IFB No.        **24-05 HVAC Upgrades at Kennedy MS & Jefferson HS**

RE:            **ADDENDUM NO. 2**

## ADDENDUM #2

PROJECT: IFB #24-04  
RPS 205 ESSER HVAC Improvements:  
2405 - Kennedy MS HVAC Revisions  
2403 - Jefferson High School Chiller Replacement  
IMEG #21002885.13, and 21002885.15

**M307**

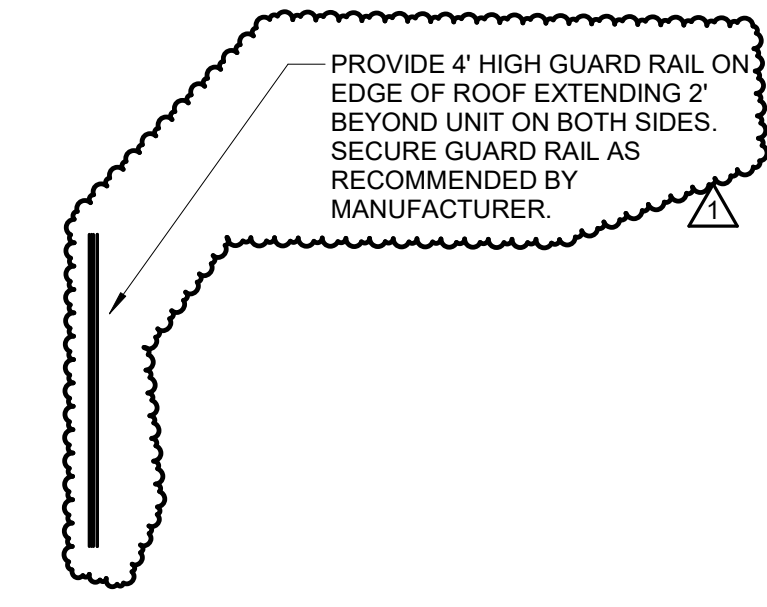
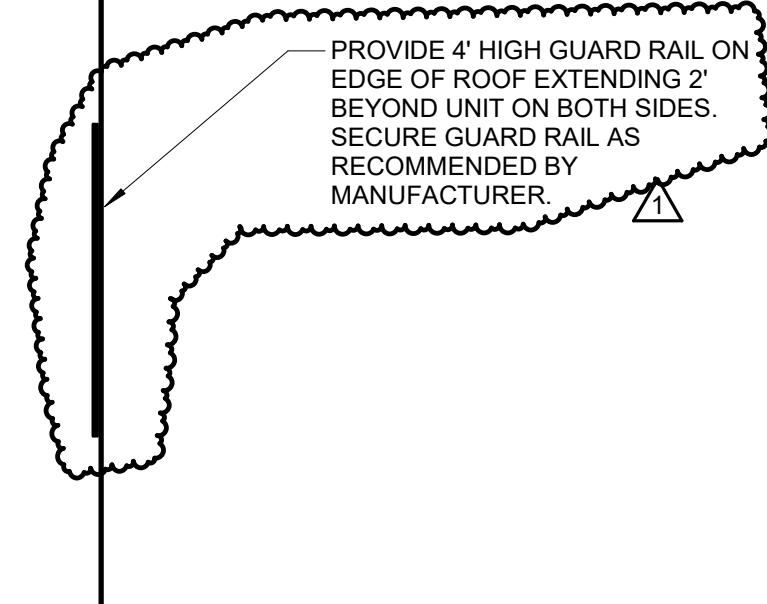
1. Drawing M307 – HVAC ENLARGED PLANS
  - a. **ADD** note to provide guard rail on two RTUs.

**M300**

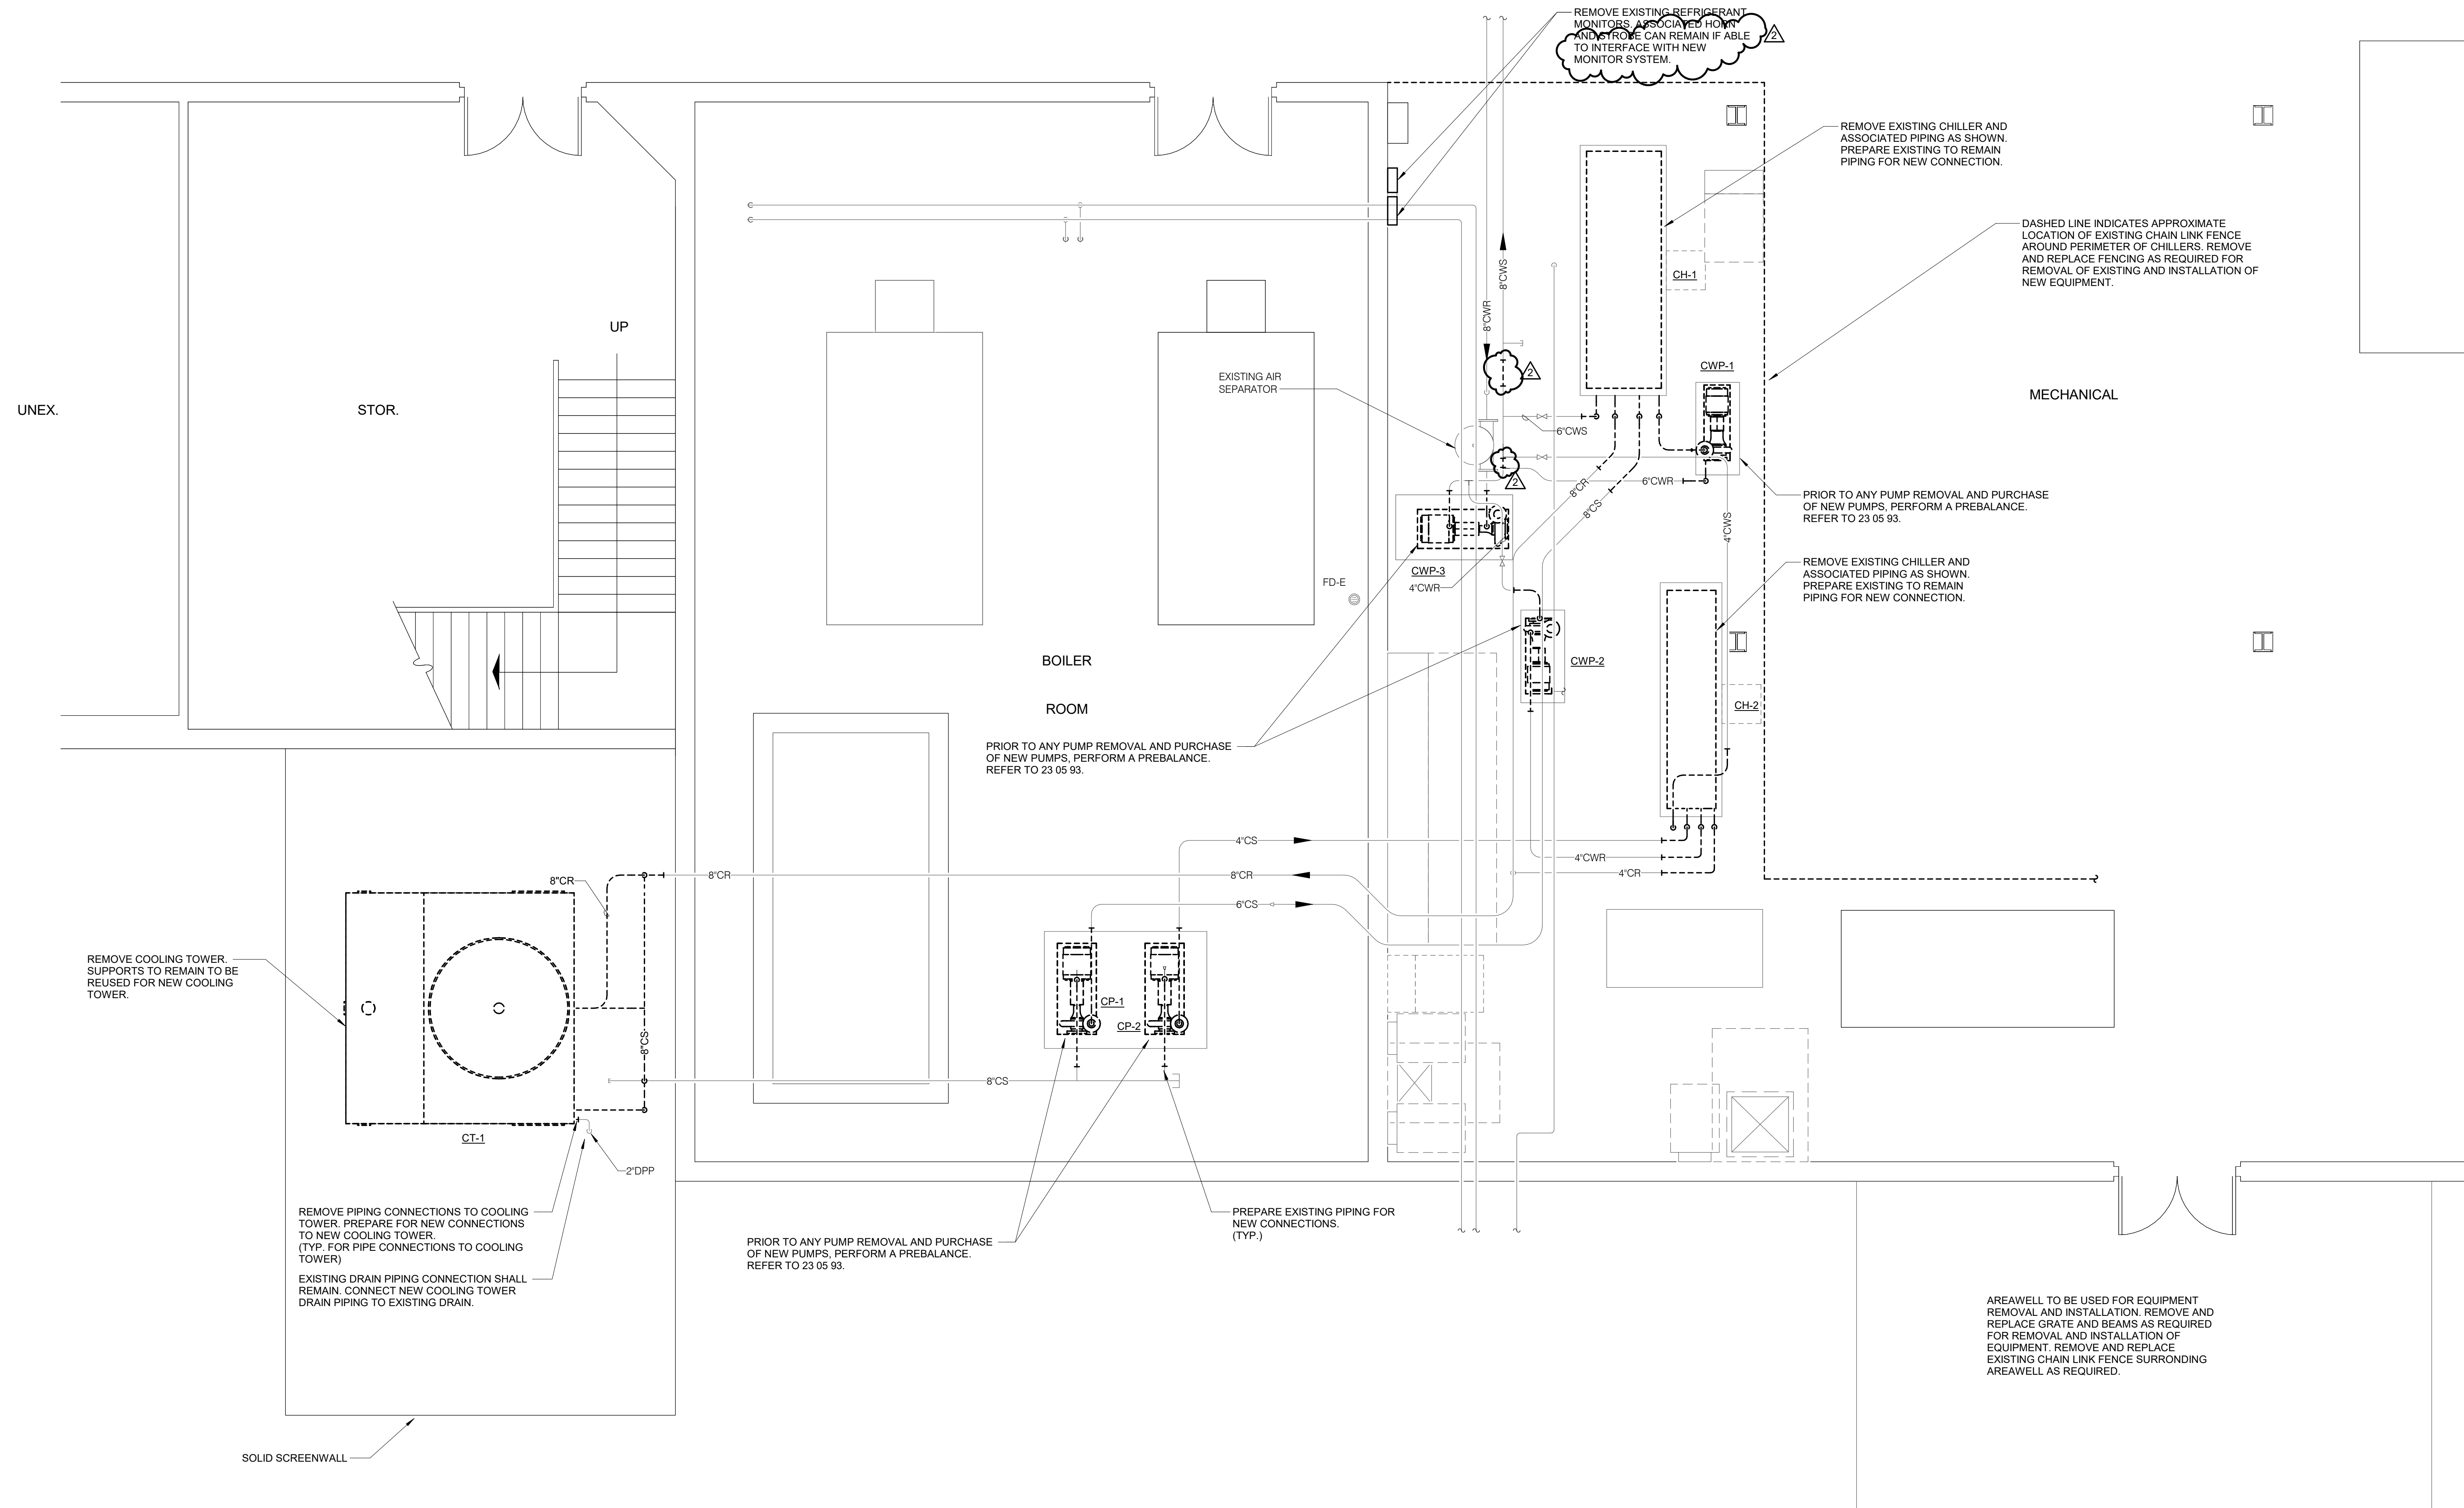
2. Drawing M300 – MECHANICAL ENLARGED PLANS
  - a. **REVISE** horn and strobe note.
3. Drawing M301 – MECHANICAL ENLARGED PLANS
  - a. **REVISE** cooling tower existing support note.
  - b. **ADD** 6” decoupler as shown.
4. Drawing M500 – MECHANICAL DIAGRAMS
  - a. **ADD** balance valves as shown.
  - b. **ADD** decoupler.
  - c. **ADD** btuh meter and associated sensors.
  - d. **REMOVE** flow meters on chiller piping.
  - e. **REVISE** pipe routing as shown.

**M600**

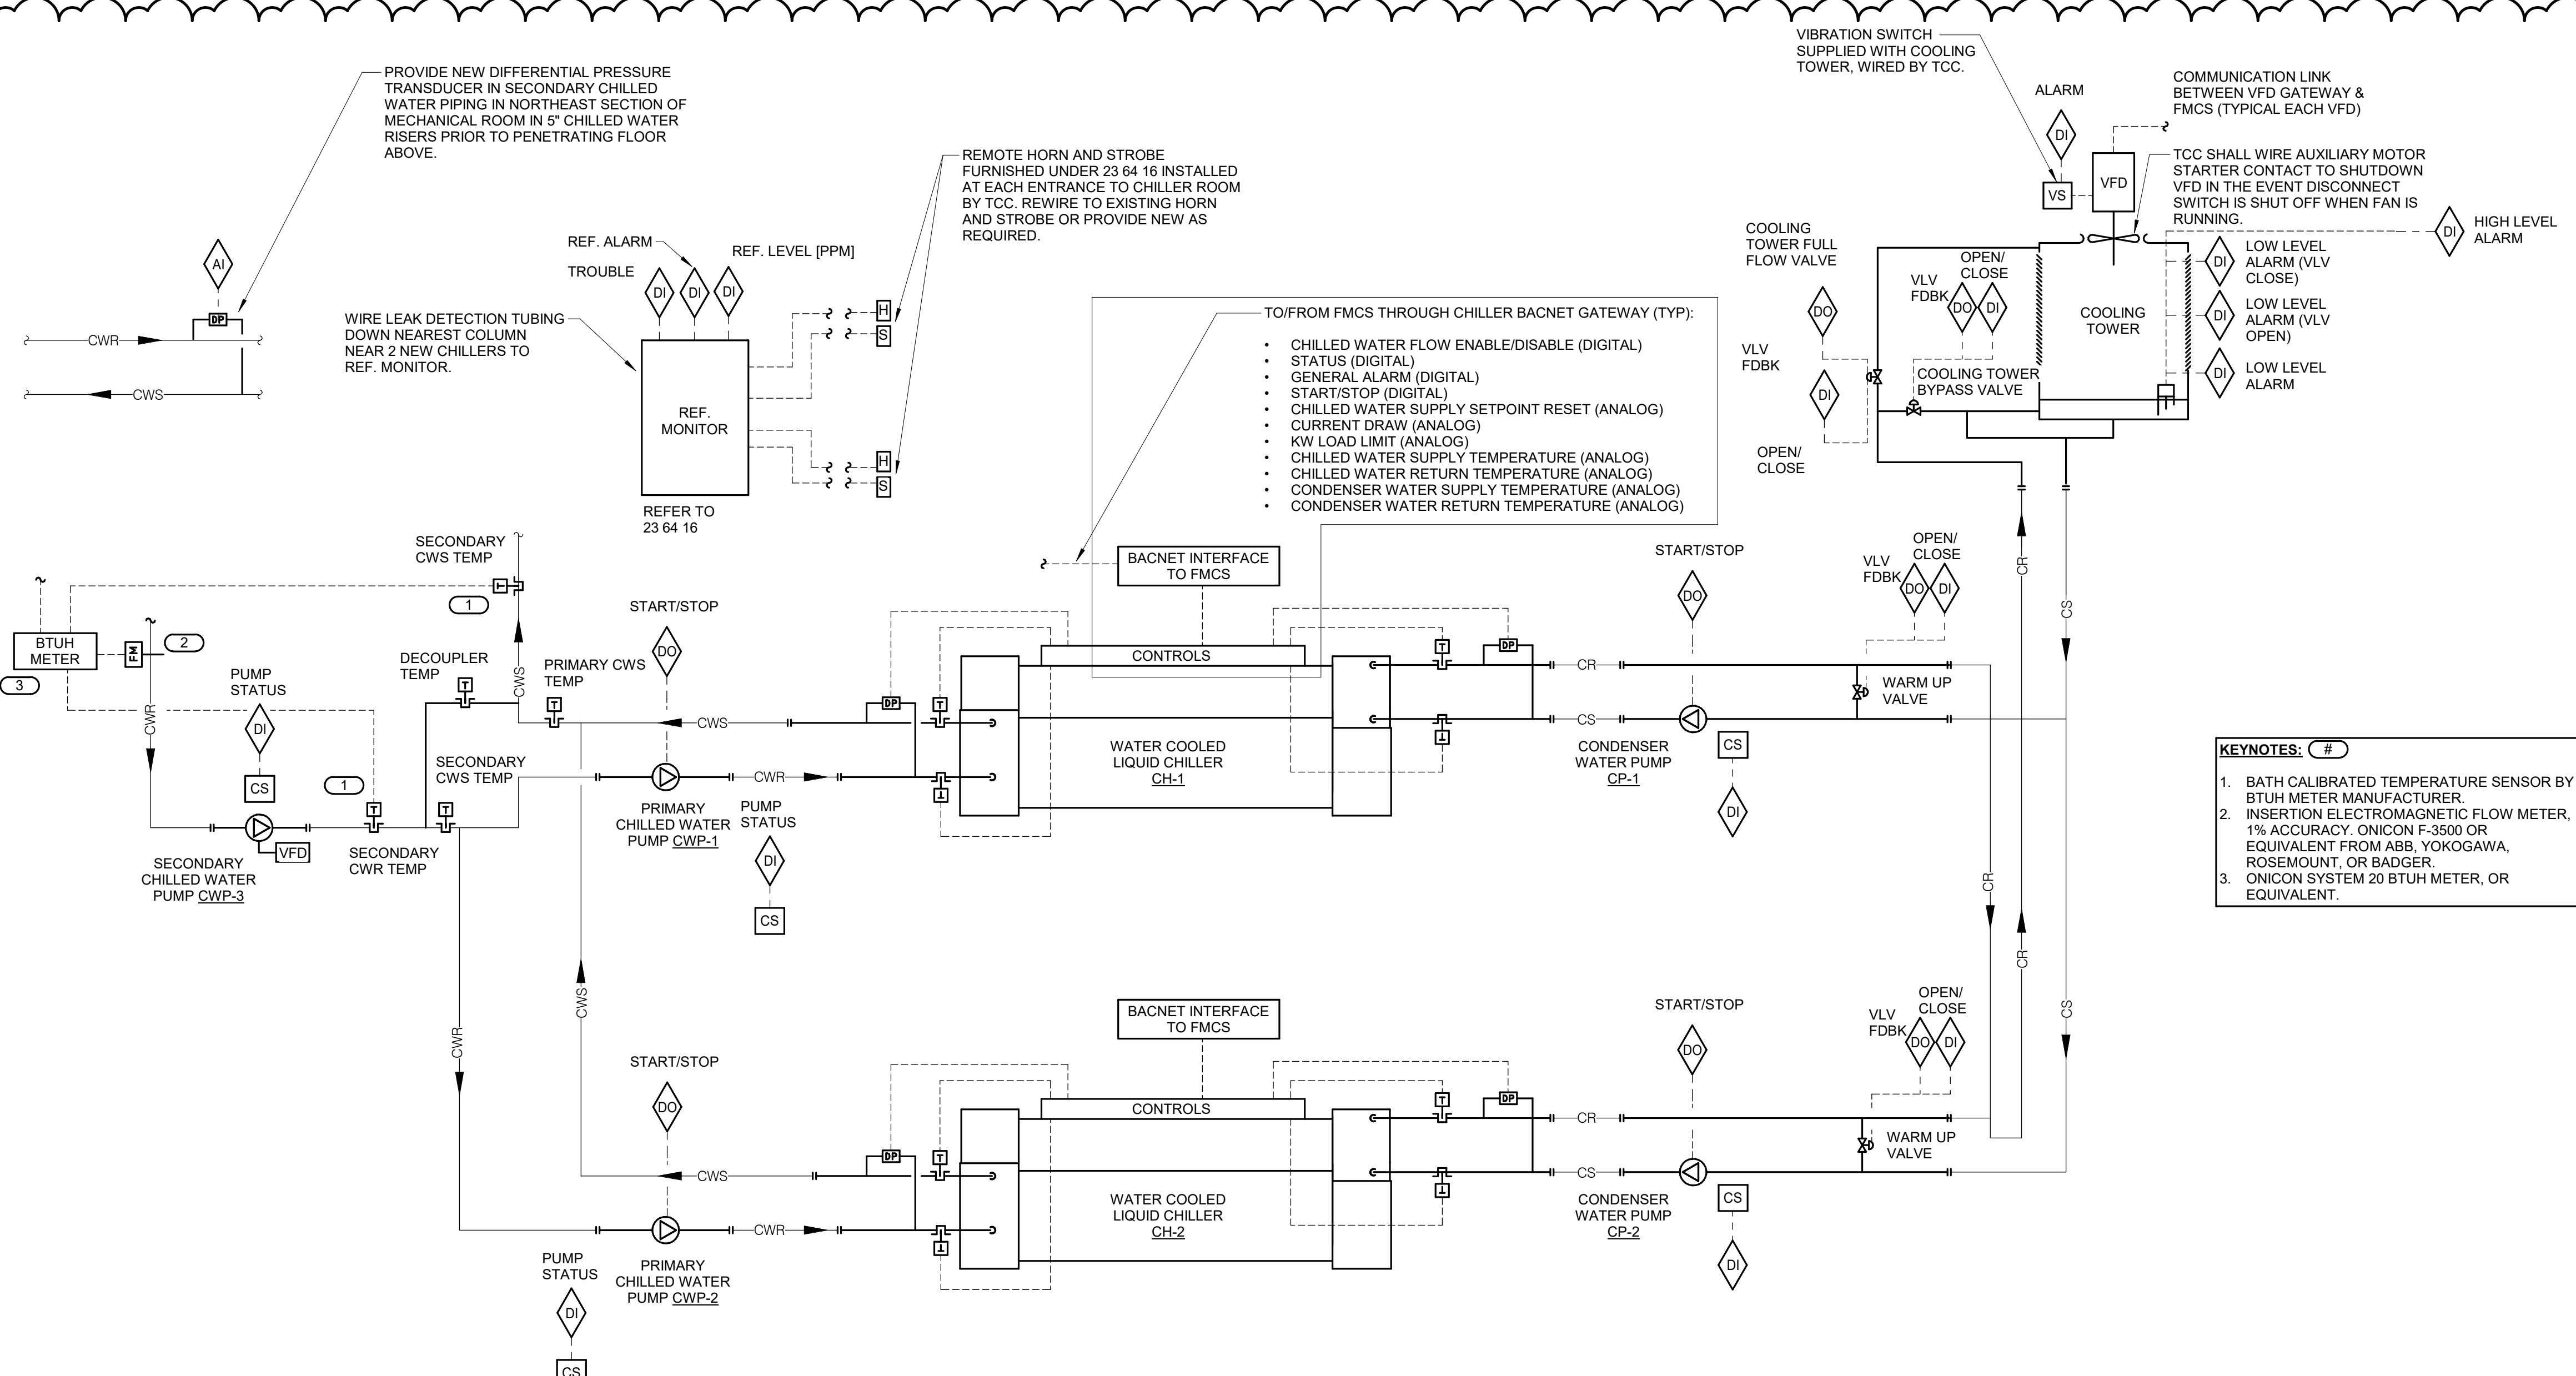
5. Drawing M600 – MECHANICAL SCHEDULES
  - a. **ADD** note to cooling tower.
  - b. **REVISE** area served on pump schedule for clarity.
6. Drawing M700 – MECHANICAL CONTROLS
  - a. **ADD** decoupler.
  - b. **ADD** btuh meter and associated sensors points.
  - c. **REMOVE** flow meters on chiller piping.
  - d. **REVISE** routing as shown.
  - e. **REVISE** sequence of operation for chiller, pump, and cooling tower.
  - f. **ADD** differential pressure sensor in secondary piping.
  - g. **ADD** cooling tower water level alarms.
  - h. **ADD** VFD control.
